# Agenda Including Addeds

6th Meeting of the Environmental and Ecological Planning Advisory Committee

**Reference:** **Sifton Properties Limited  
Responses to City of London and Upper Thames River Conservation Authority  
Comments Regarding the Proposed Caverhill Subdivision (File #TS2017-004)  
Official Plan & Zoning By-law Amendment and Draft Plan of Subdivision  
2331 Kilally Road and 1588 Clarke Road**

## Responses to EEPAC Comments on the Draft Plan of Subdivision File 9T-20502 - 2331 Kilally Rd and 1588 Clarke Rd.

**Figure 8**

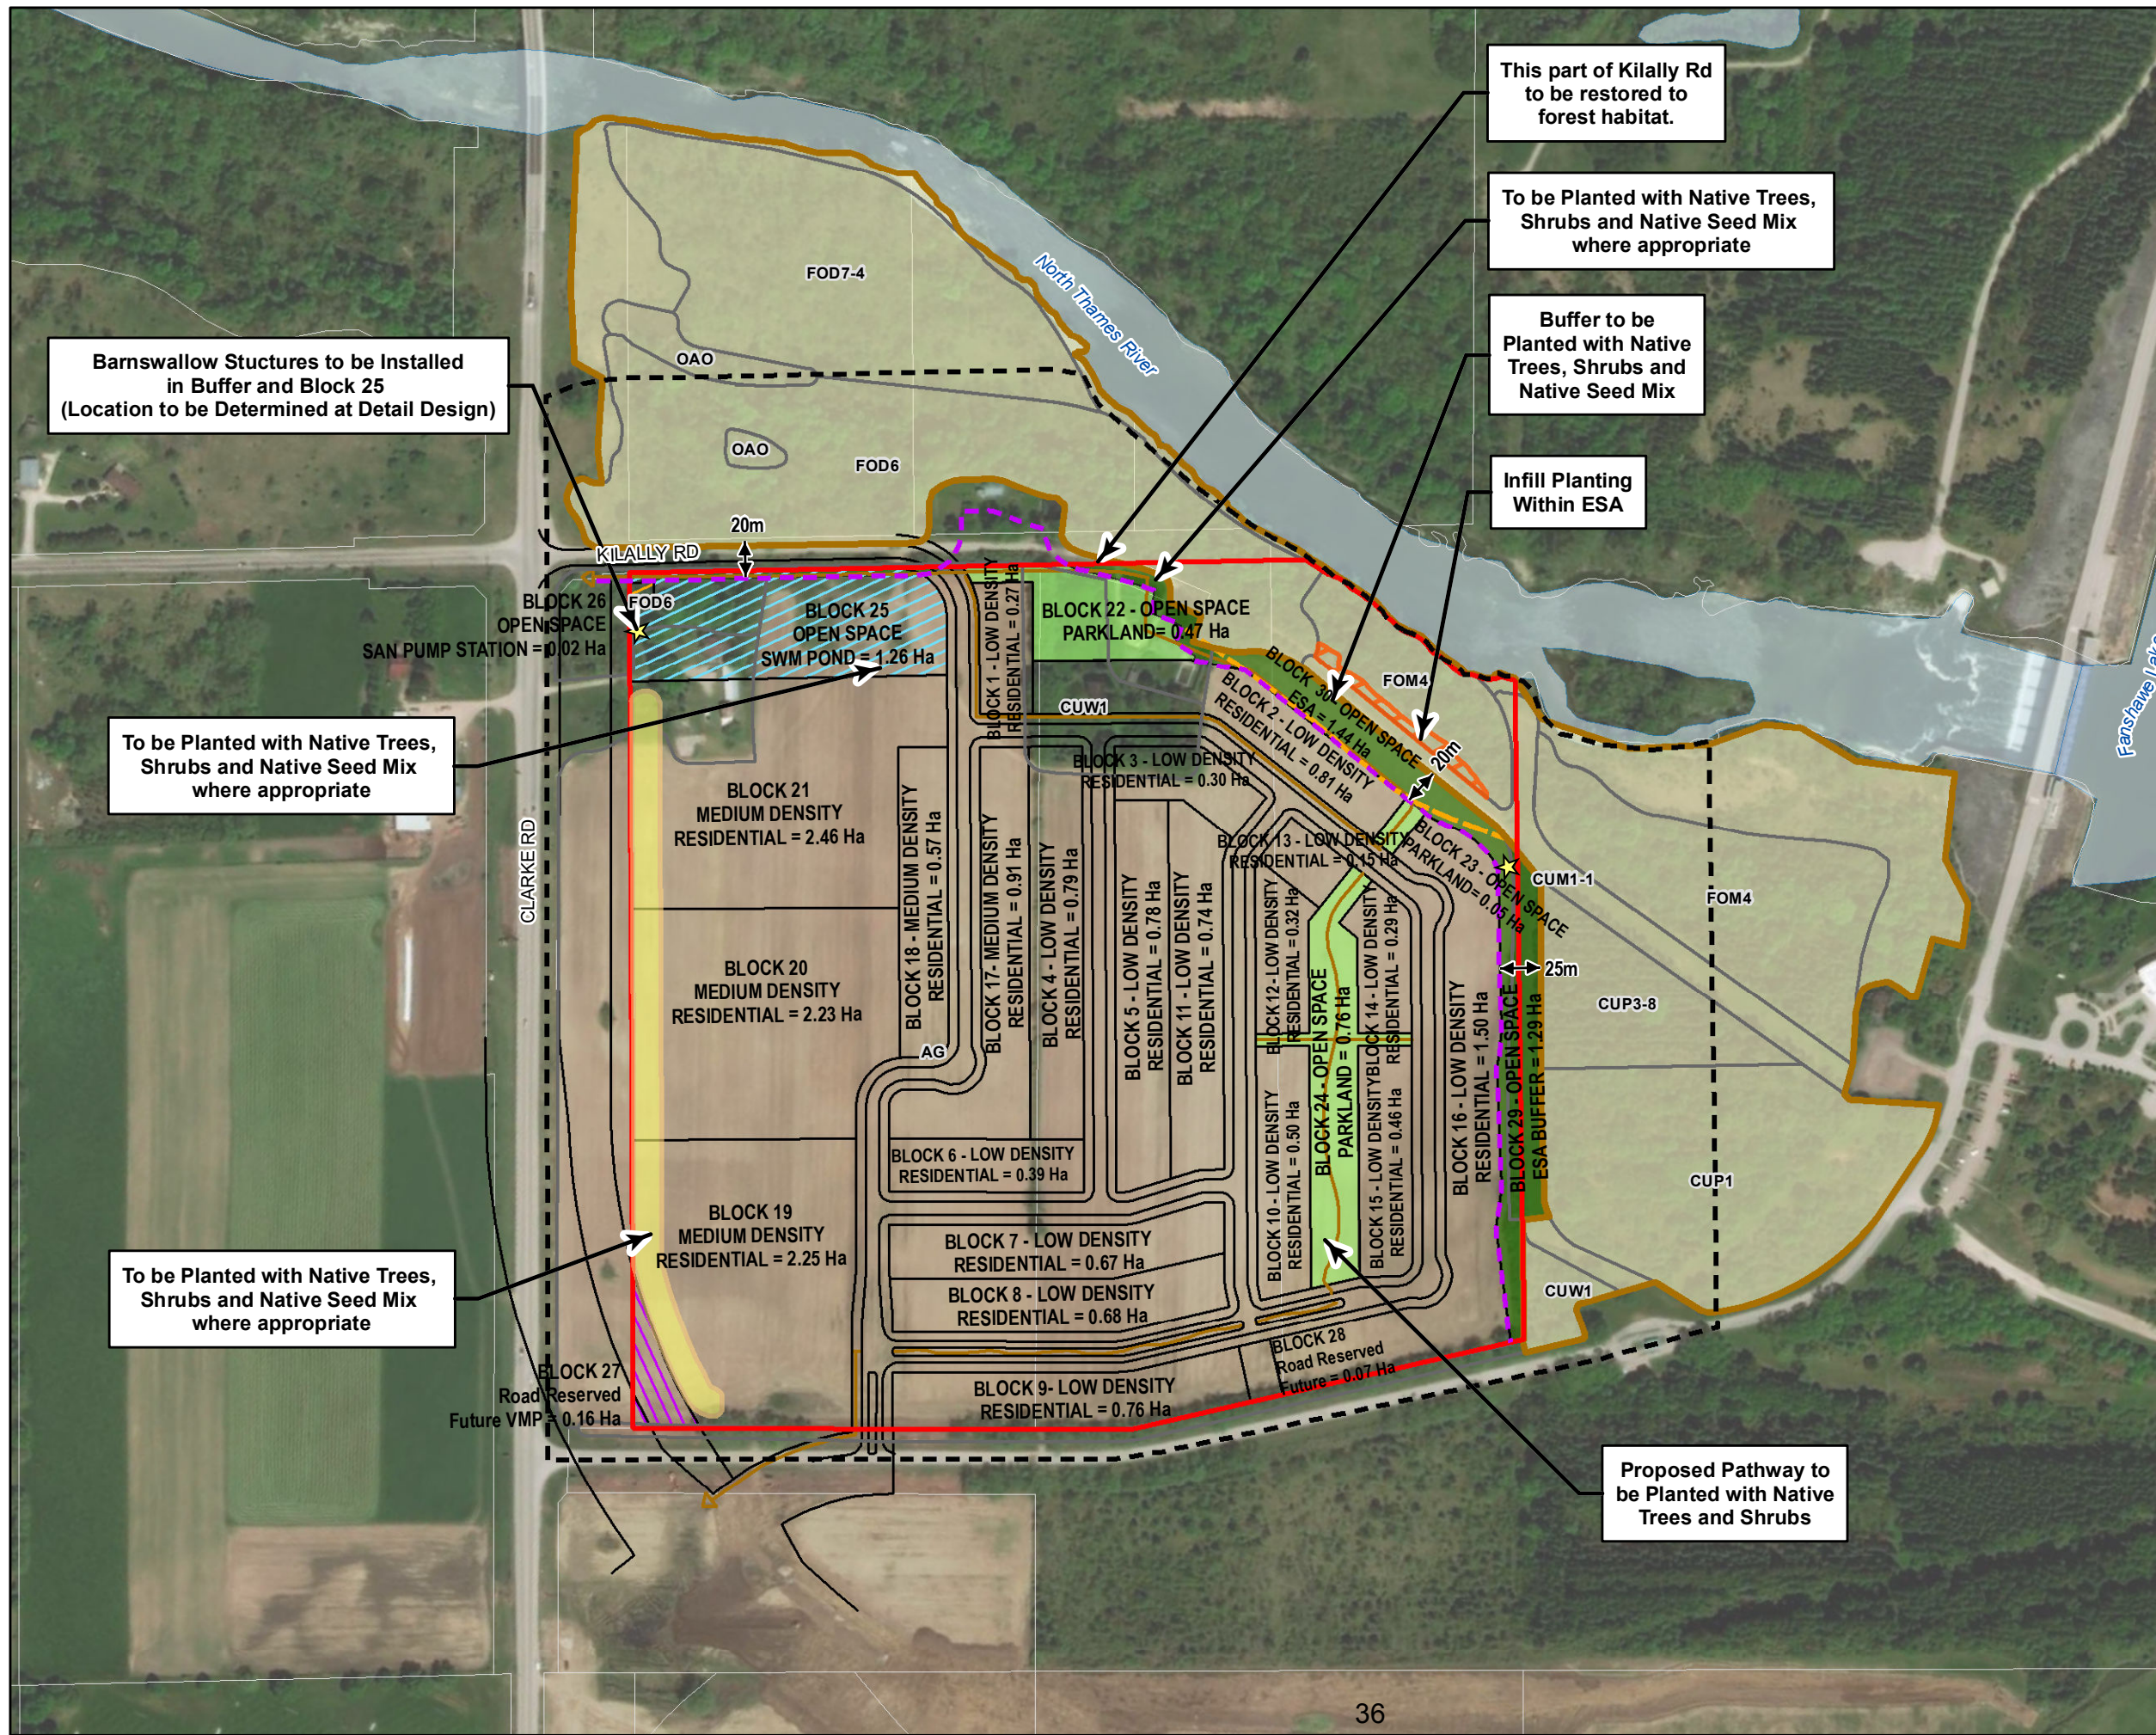
The City's Ecological Planner has provided comments on the EIS prepared by AECOM in 2020 for the proposed subdivision, primarily addressing the proposed buffer, trail placement, and study methodology. Detailed responses to each comment are provided in the enclosed table, as well as an addendum to the EIS prepared by AECOM with more information on ecological buffers, management of parkland blocks, the

alignment of the multi-use trail, and infill planting. It is anticipated that a final EIS addressing the comments provided by the City of London Development Services will be included as a condition of Draft Plan approval. *Environmental and Ecological Planning Advisory Committee Comments*

We have revised our Environmental Management Plan **Figure 8** (attached) with the most recent Plan of Subdivision, showing the ecological buffers, park blocks, stormwater management block and revised trail alignment. Relevant updates to the Plan of Subdivision include:

We have removed the infill planting areas shown within UTRCA lands and have included an area inside of the proponent owned lands (shown on Figure 8). The area proposed for infill planting is the area of exposed slope within the delineated Dry-fresh White Cedar Mixed Forest (FOM4) community, but outside of the forest dripline. As noted above, this inclusion is recommended for tree and shrub planting to increase the area of the forest community and to stabilize the slope.
